A1 in Northumberland: Morpeth to Ellingham

**River Coquet Geomorphology Modelling
Assessment**

River Coquet Geomorphology Modelling Assessment

ENVIRONMENT AGENCY QUERIES

Manning's n Values

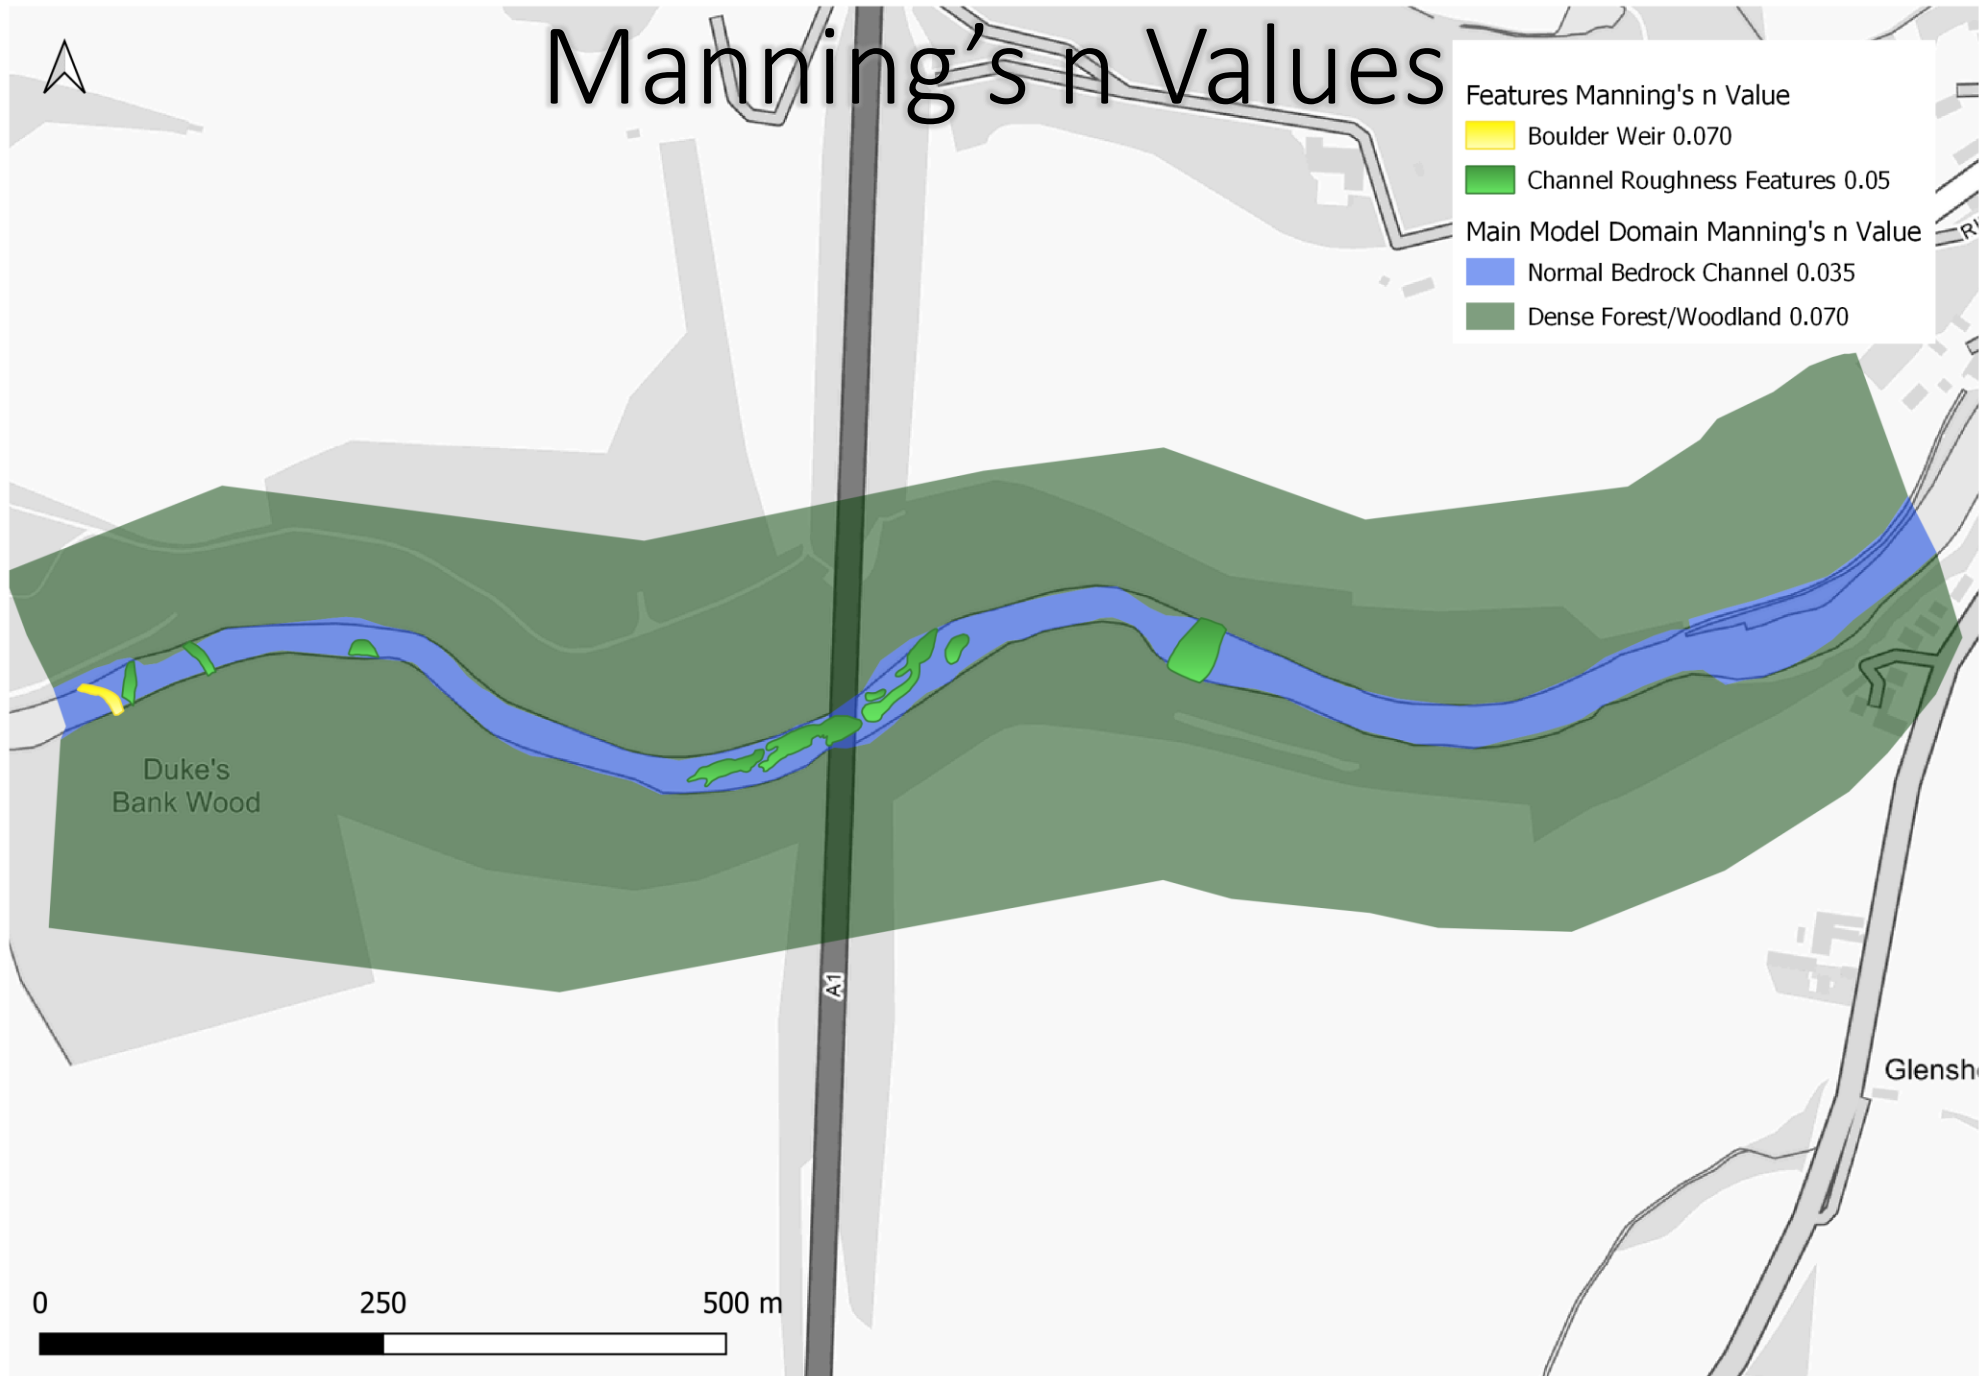
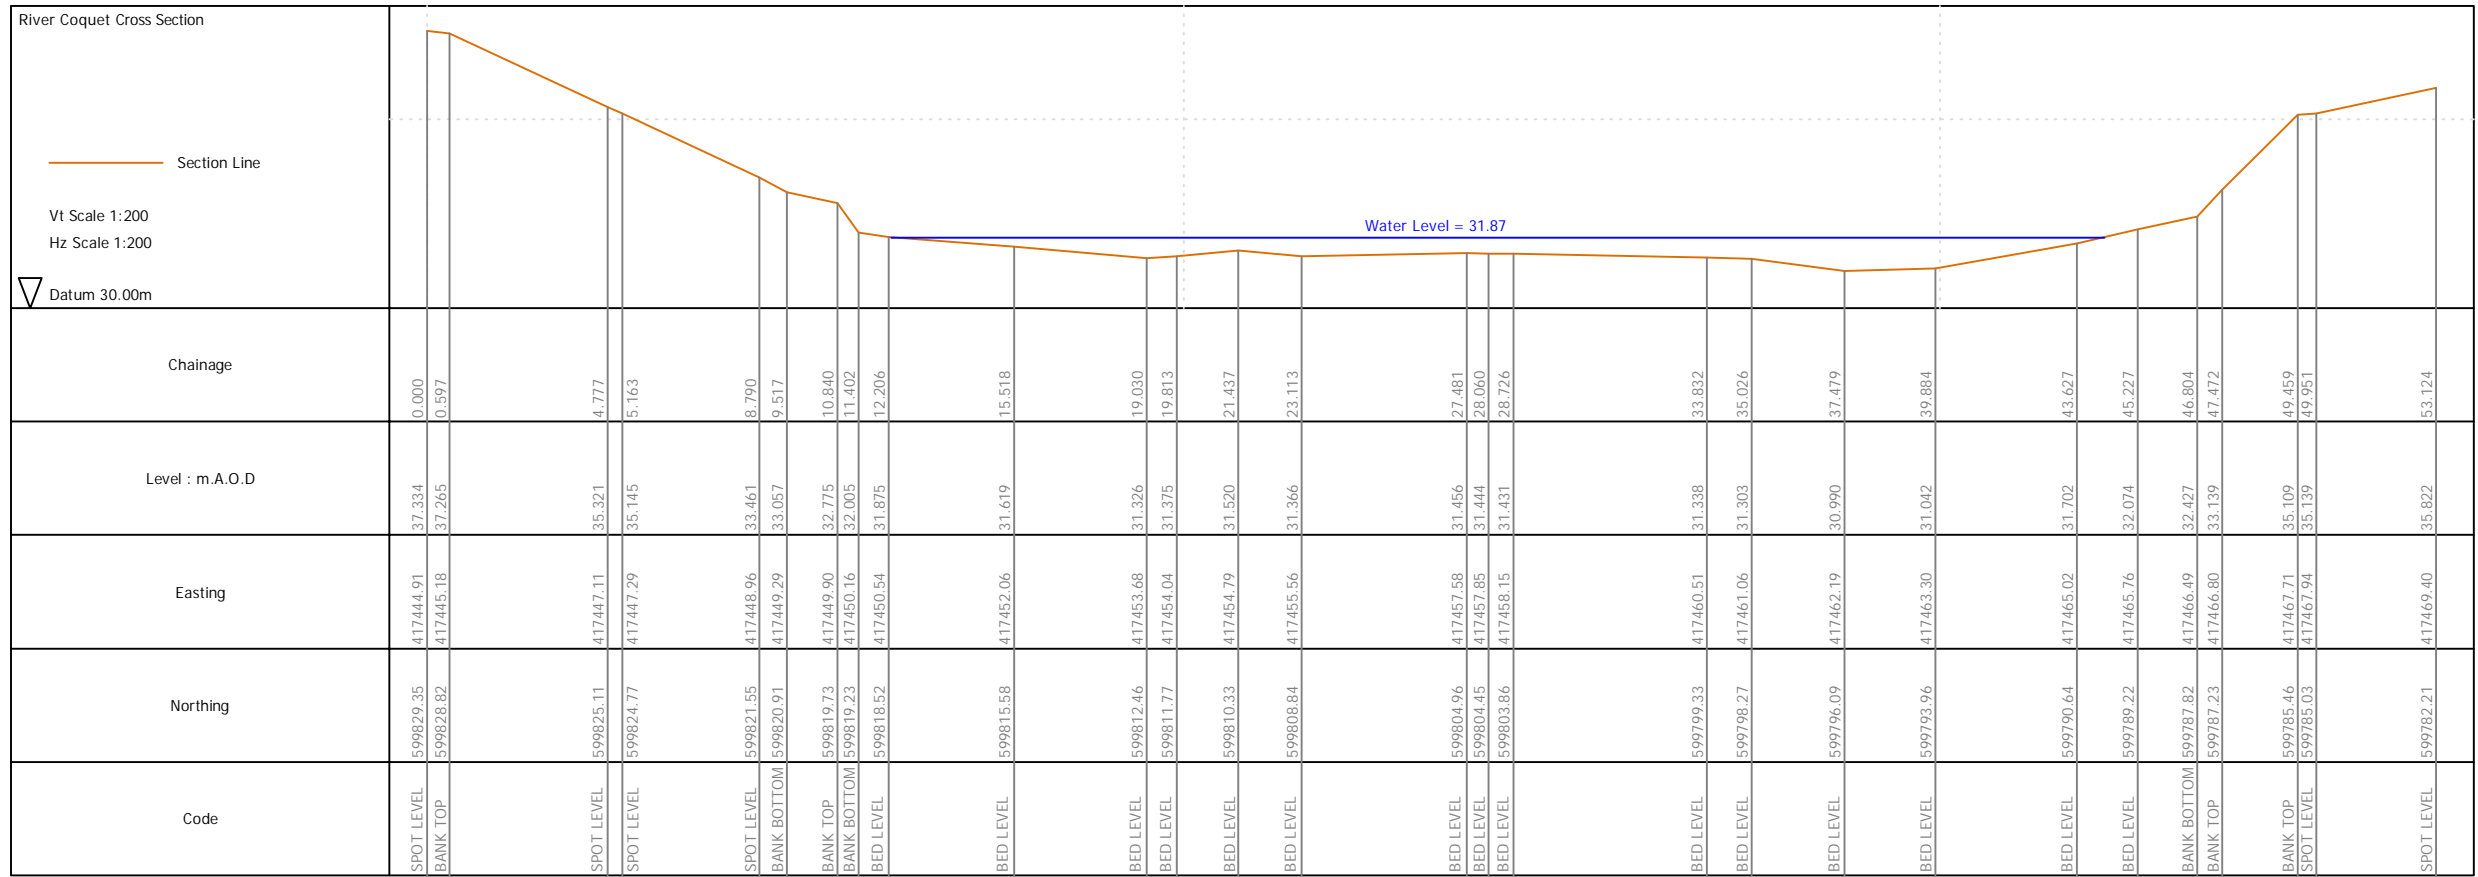
4	Rational for using a single manning's number for all scenarios. The number feels high for a bedrock channel, especially mid channel where the majority of the sedimentary deposits are located;	<p>[redacted] and [redacted] explained the inclusion of multiple Manning's values in the 2D model to better represent roughness. [redacted] happy with values. [redacted] confirmed that a sense check on highest flow would be carried out.</p> <p>[redacted] also provided further explanation of why a mix of Manning's values were used in the initial assessment report and a single value in the Parameter 10 report. The first report the Manning's values were set by the WSP geomorphology team with different values used to reflect out-of-bank flows for baseline, proposed and the construction phase.</p> <p>For the Parameter 10 report, the hydrological data was provided by CJP, who had used a single value. Due to time constraints for completing the Parameter 10 assessment, it was not feasible to have the calculations re-run and meet the submission deadline.</p>

- Features Manning's n Value
- Boulder Weir 0.070
 - Channel Roughness Features 0.05
- Main Model Domain Manning's n Value
- Normal Bedrock Channel 0.035
 - Dense Forest/Woodland 0.070
